AUTOMATIC TRANSMISSION SERVICE GROUP

REVISED EDITION

Since the introduction of the THM 440-T4 Transaxle in April, 1984, there have been many major engineering design changes. These changes have affected nearly every part used in the THM 440-T4. This Update Handbook will explain each change, the parts affected by the change, and any parts interchangeability problems created by the change.

Figure 5

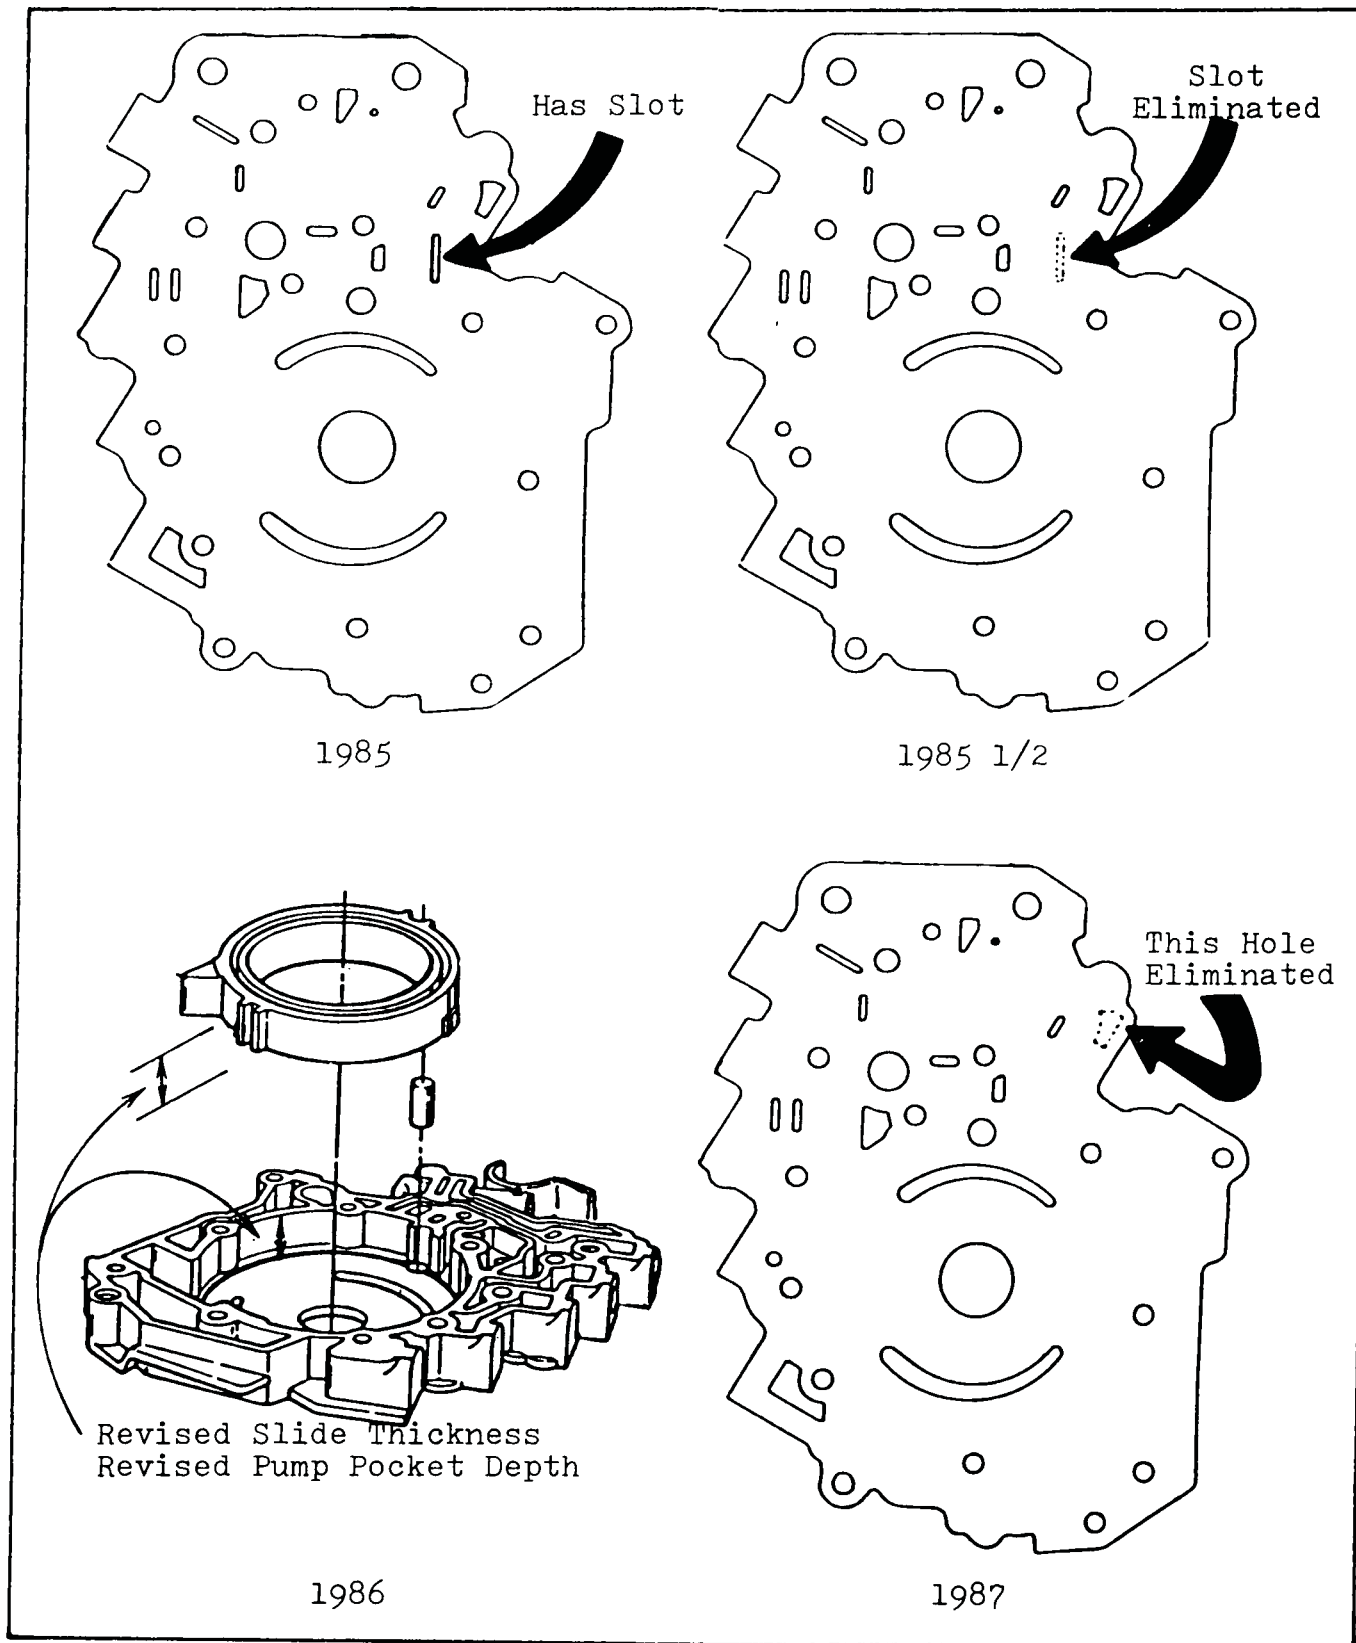
1985	Identification:	Has slot in pump body (See Figure 5).
	Interchangeability:	The 1985 pump body will not work on 1985 1/2 up valve body unless spacer plate is used to eliminate slot. If used without the spacer plate result will be tie-up when transaxle shifts to 4th gear.
1985 1/2	Identification:	Slot in pump body was eliminated (See Figure 5).
	Reason:	Addition of 3-2 TV bias valve in valve body and complete revision of hydraulic circuit for improved 3-2 downshift.
	Interchangeability:	Will interchange on 85 1/2 and 1986 models only.
1986	Identification:	No way to identify from 1985 1/2. Pump pocket depth was made shallower by .001" which created 5 new slide sizes unique to the 1986 pump. See chart on page 6.
	Reason:	Improved pump capacity.
	Interchangeability:	Will interchange with 85 1/2 only, as long as proper slide selection is made to correspond with depth of pump pocket.
1987	Identification:	Hole eliminated in pump body (See Fig. 5).

Reason:	Improved 3-2 downshift. Modulator oil was fed thru the hole in pump body to stroke the 3-2 coastdown valve. Improved 3-2 downshift could be obtained by using servo release oil to stroke the valve, so hole was eliminated and the 3-2 maneuver pipe was added to carry servo release oil to the 3-2 coastdown valve in pump body (See Figure 6). This also made a change in the pump cover necessary with an additional hole and seal to accept the 3-2 maneuver pipe.
	Interchangeability:	Will retro fit back to 85 1/2, and is recommended. The 3-2 maneuver pipe must be used with it. Not interchangeable unless 3-2 maneuver pipe is used.

Figure 7

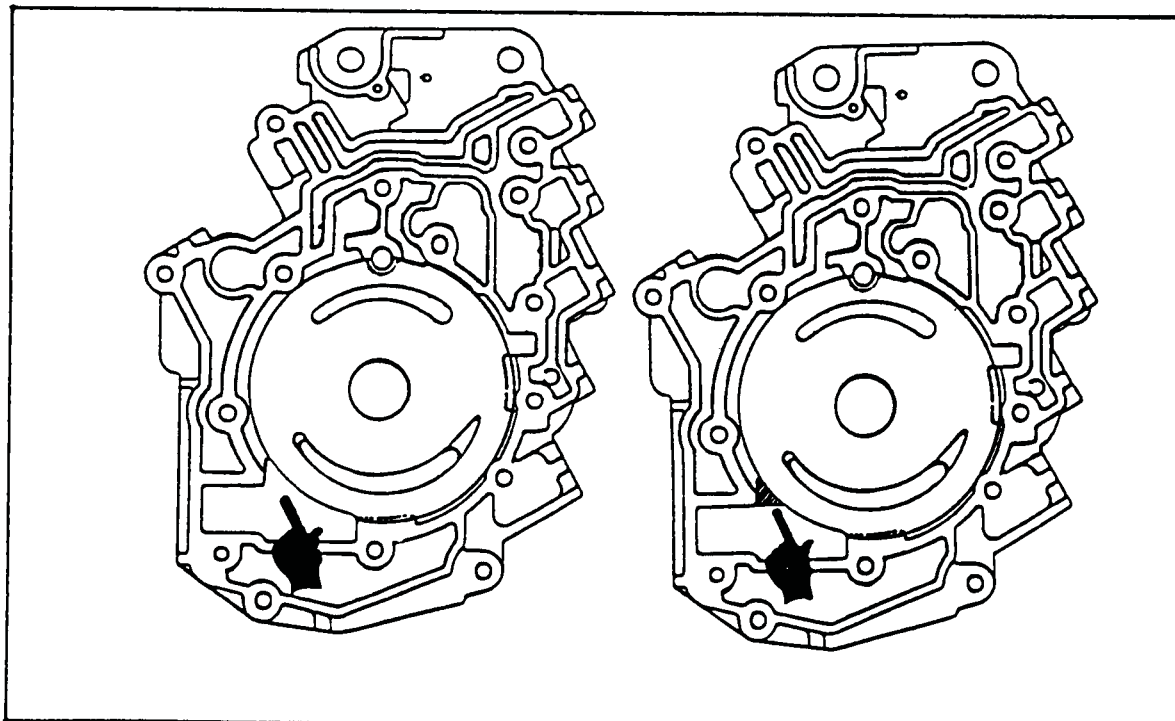
Some 1987 440-T4 transaxles built between November 26, 1986 (Julian Date 330) and January 12, 1987 (Julian Date 012), may exhibit a slip or no drive condition as a result of low line pressure.

This condition may be caused by the pump slide binding on excessive casting flash when the slide is in the low pressure position.

If pressures do not vary with vacuum signal changes, inspect for pump slide bind by removing the oil pump cover and slide springs. If present, excessive flash will cause the slide to bind when the cover is on and torqued.

If flash is present you will have to replace the oil pump assembly, or use a Dremel Tool with a carbide bit and remove flash from 87 model to match contour of 86 model (See Figure 7).

Figure 8

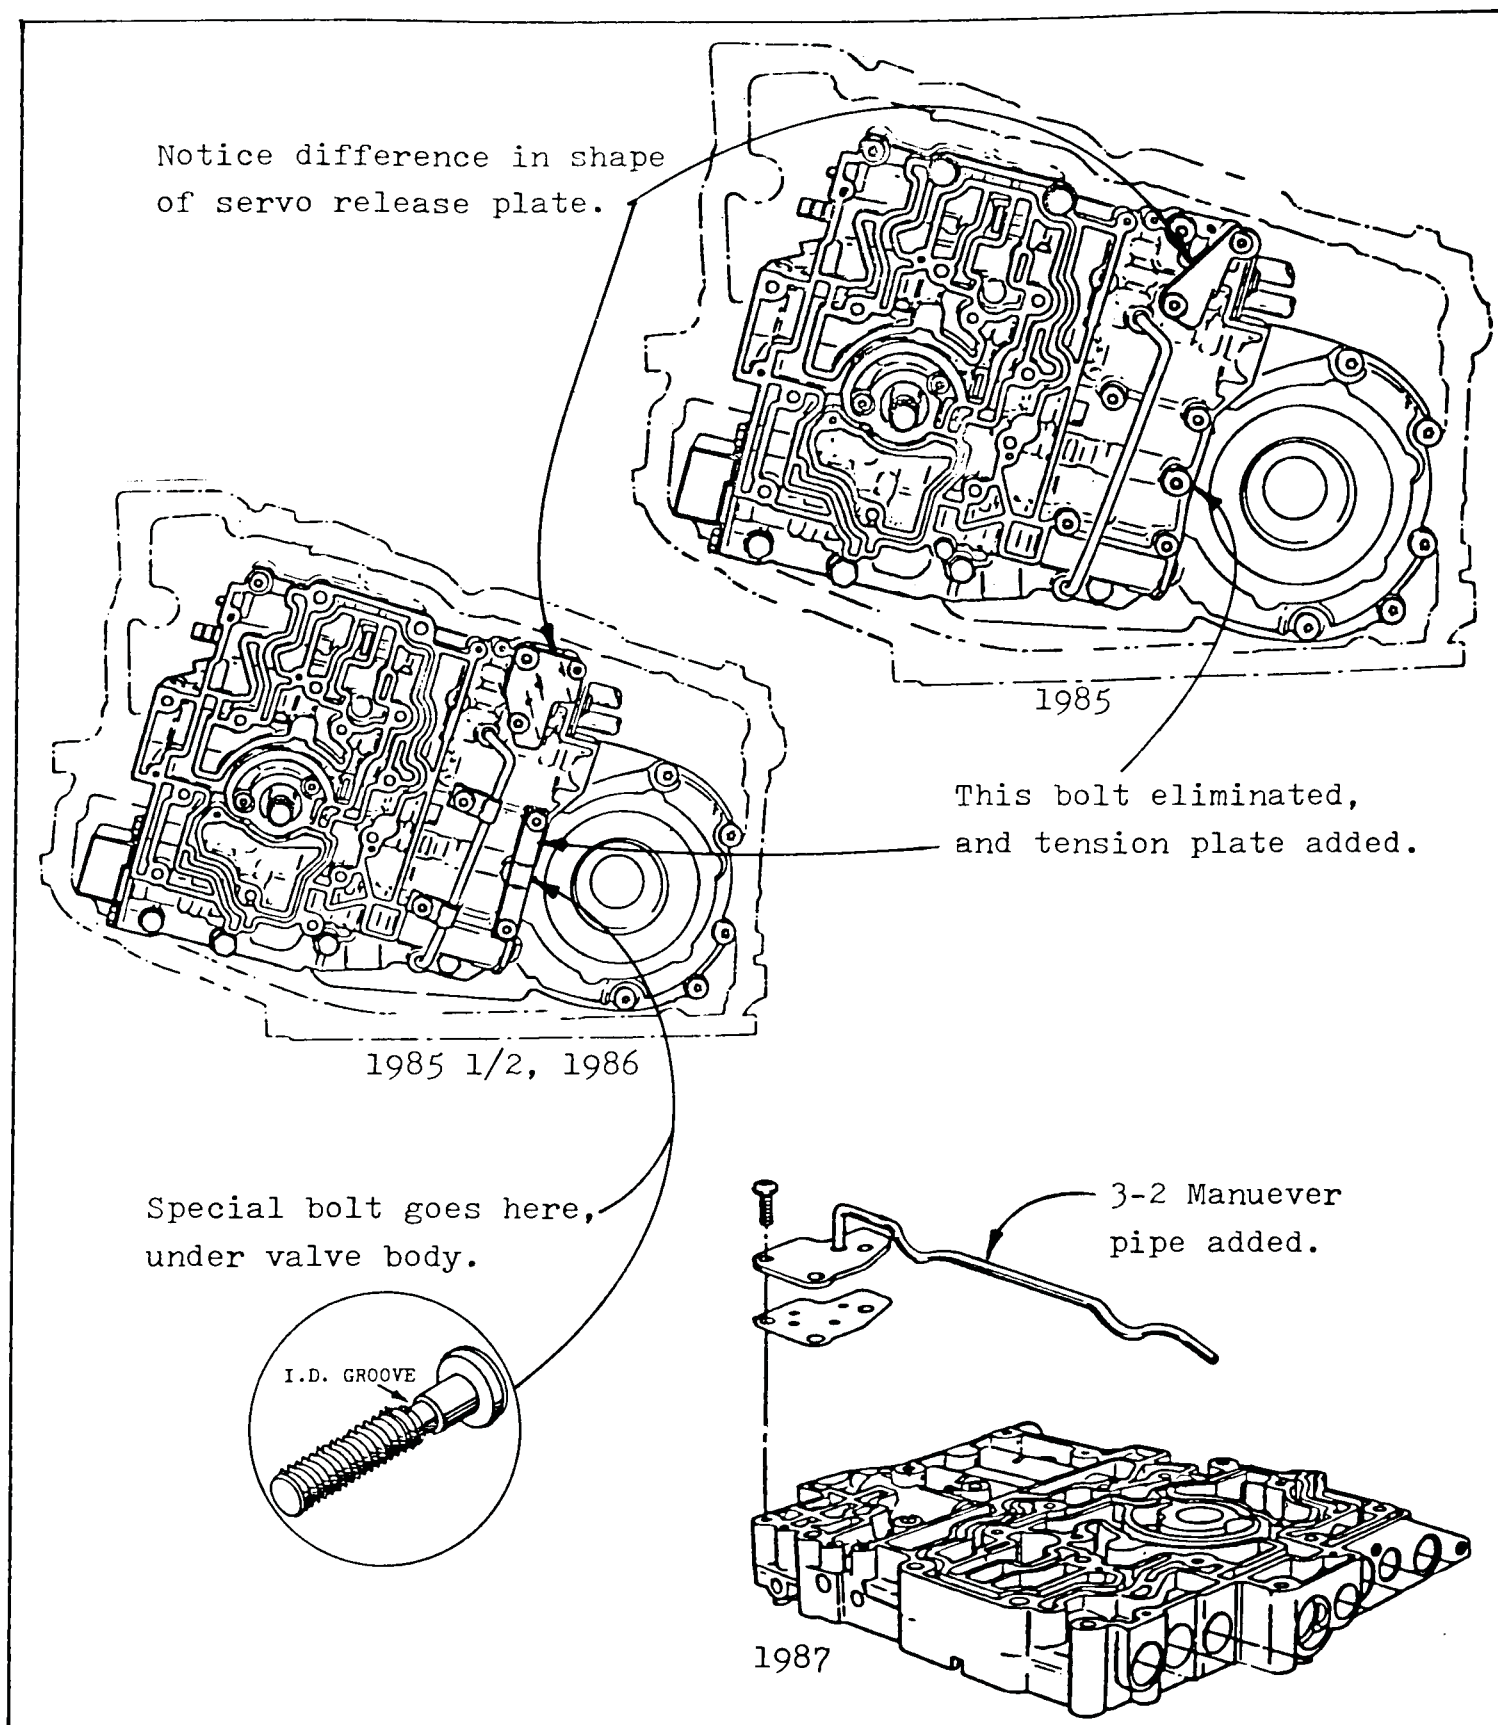
1985	Identification:	Notice difference in shape of 1-2 servo release plate. Also extra bolt in valve body (See Figure 8).
	Interchangeability:	NOT INTERCHANGEABLE.
85 1/2, 86	Identification:	Notice difference in shape of 1-2 servo release plate (See Figure 8). Extra bolt eliminated in valve body to make room for the addition of 3-2 TV bias valve in valve body (See Fig. 9). Special bolt added under valve body in channel plate, and addition of tension plate (See Figure 8).
	Reason:	Improved 3-2 downshift.
	Interchangeability:	Not Compatible with 1985. Will interchange with 86 models, as long as calibration requirements are met.
1987	Identification:	Addition of 3-2 maneuver pipe (See Figure 8).
	Reason:	Further improved 3-2 downshift.
	Interchangeability:	Not compatible with 1985. Will interchange with 85 1/2 and 86 models, as long as calibration requirements are met.

Figure 16

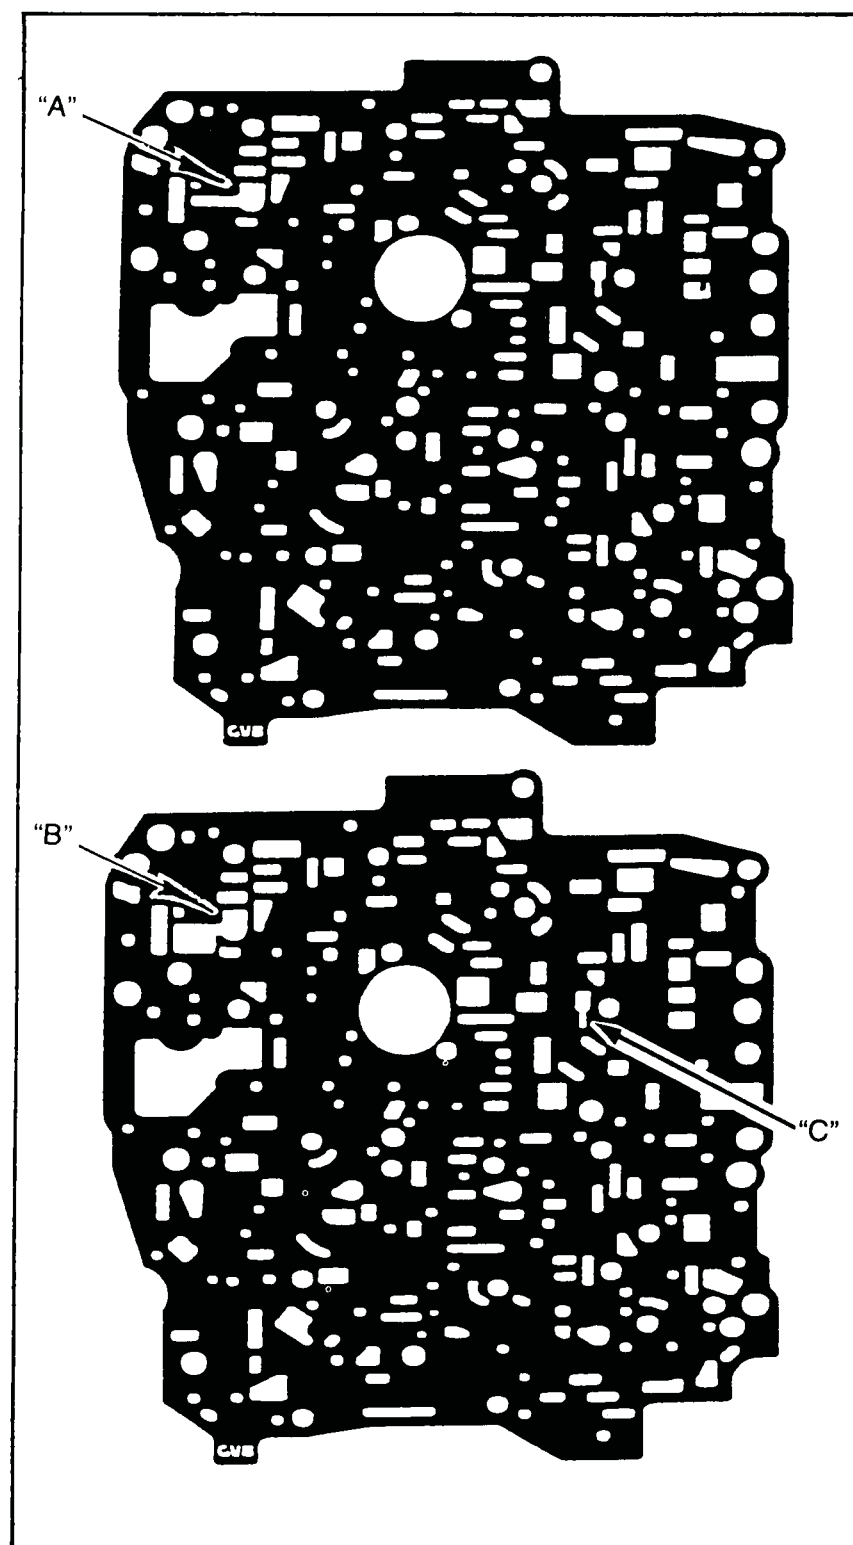
Note the difference in the "Pipe Stem" between "A" and "B", Figure 16. This change occurred about Oct. 1985.

In June 1987 the "Finger" shown at "C", Figure 16 was made Approx. .020 wider.

Figure 17 (1985 Only)

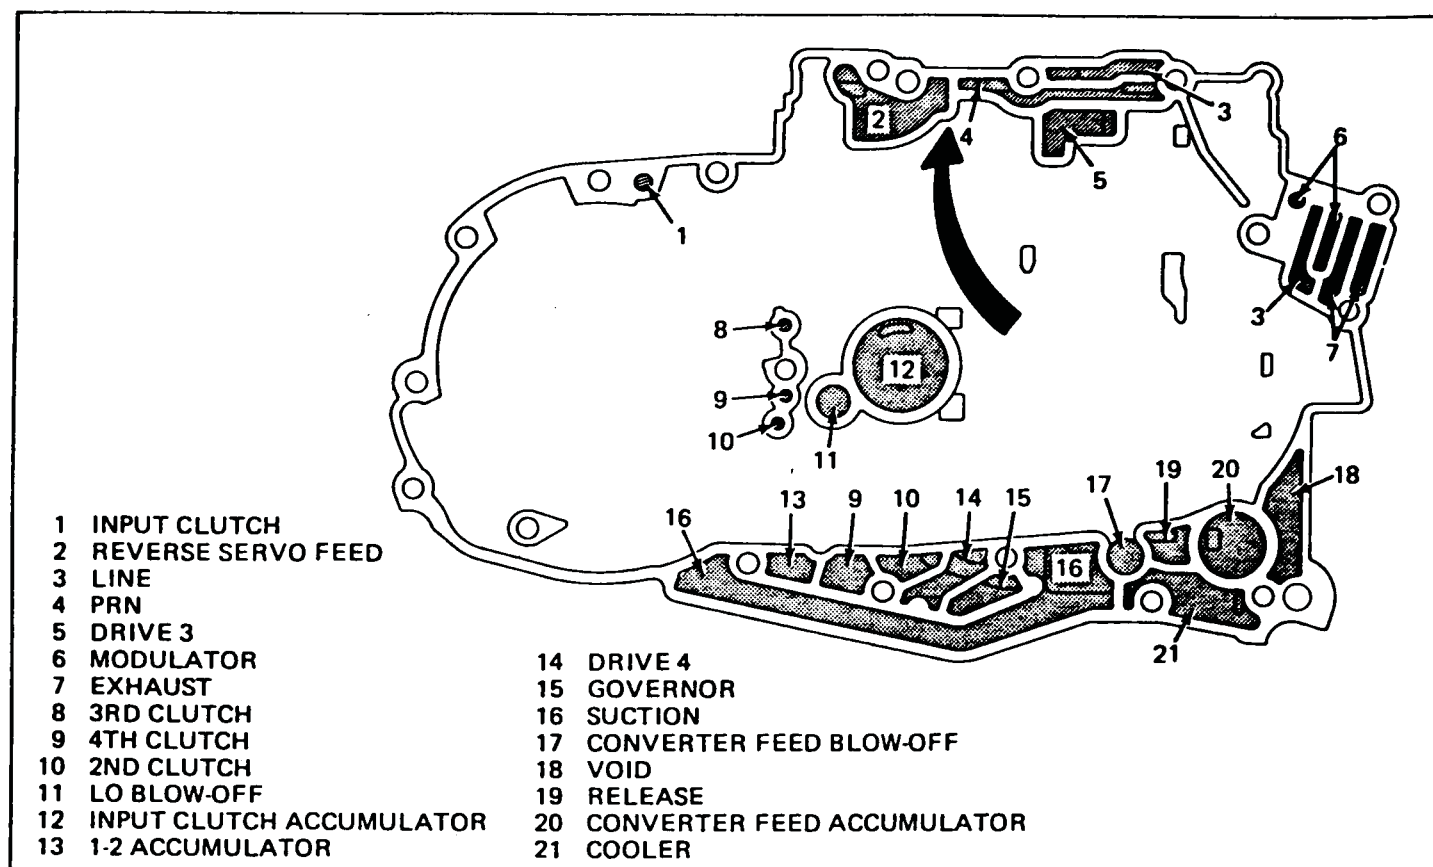
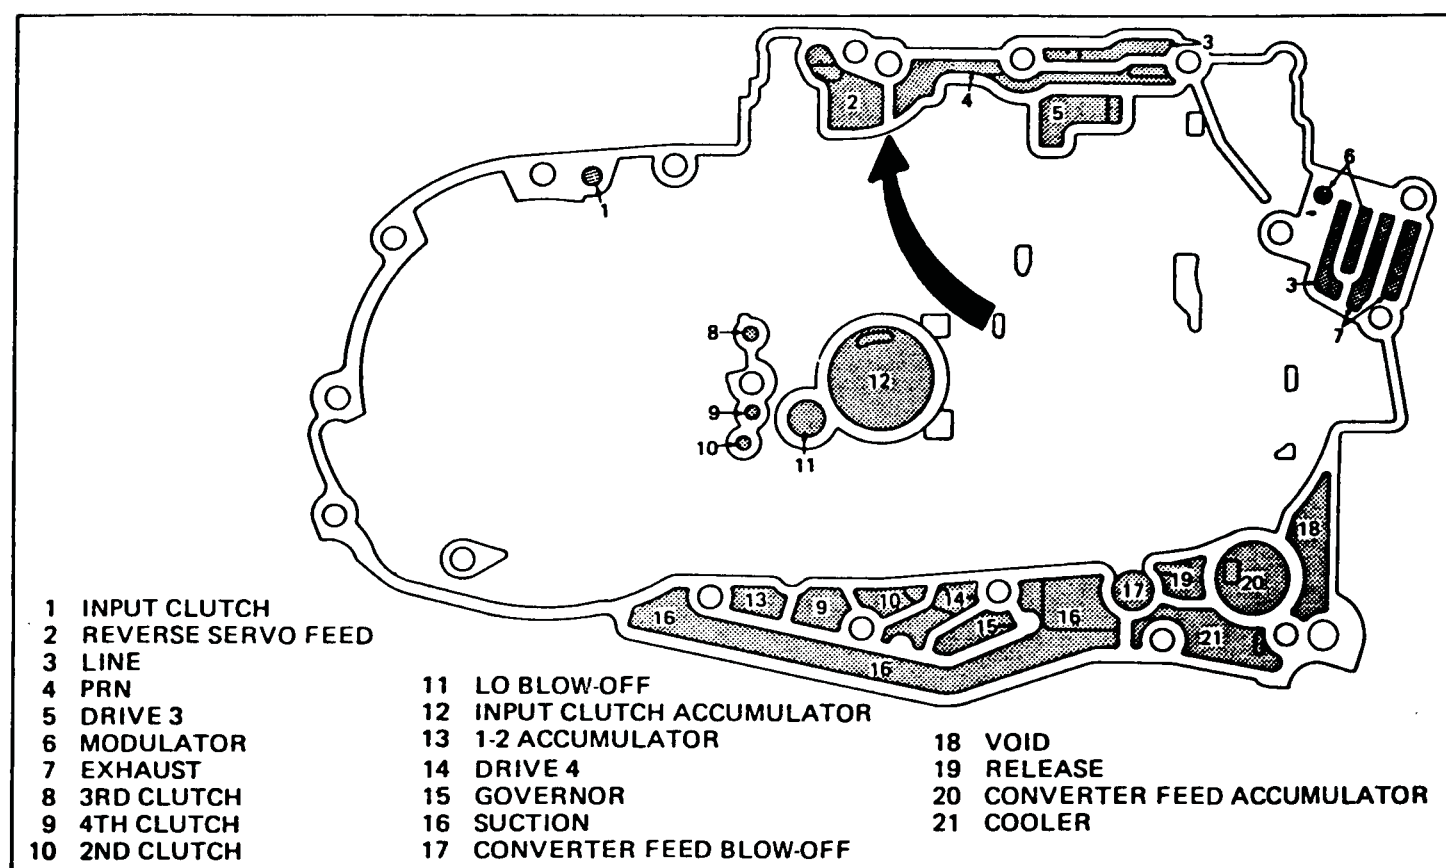
Identification: The easiest way to identify the channel plates apart is the location of the dam in the upper channel plate worm track area. (See Figure 17 and Figure 18). The dam was moved to an area directly under the upper dowel pin bore.

Reason: Complete change in hydraulic system for improved 3-2 downshift.
